Service Bulletin for AVT 100/150/275 Static Problem/Dead OD Channel

TITLE	STATIC MOD
DWG. No.	SK0000126
ISSUE	A

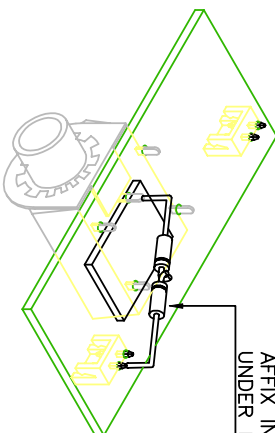
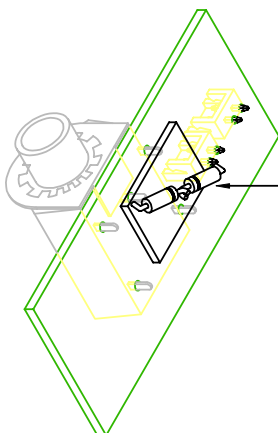
The problem with overdrive channel failures on the early production runs of AVT 100/150/275's has been identified as being caused by static discharge through the amplifier's input jack socket. An RFC (request for change) procedure has been implemented which will see the fitting of two small zener diodes on the input jack socket boards of these models, which will serve to clamp the static discharge potential to a low, non-destructive level. This will eliminate the present problem. Please view the Static mod schematic on the next page for the correct placement of the two zener diodes.

FIT DIODES AS SHOWN
AFFIX INSULATING PAD
UNDER DIODES.

FIT DIODES AS SHOWN
AFFIX INSULATING PAD
UNDER DIODES.

After installing diodes for static discharge, check unit for DC ramping of the overdrive op-amp. These are the op-amps to check in the AVT series:

- 1.AVT 100- IC6
- 2.AVT 150(H) and AVT 275-IC8
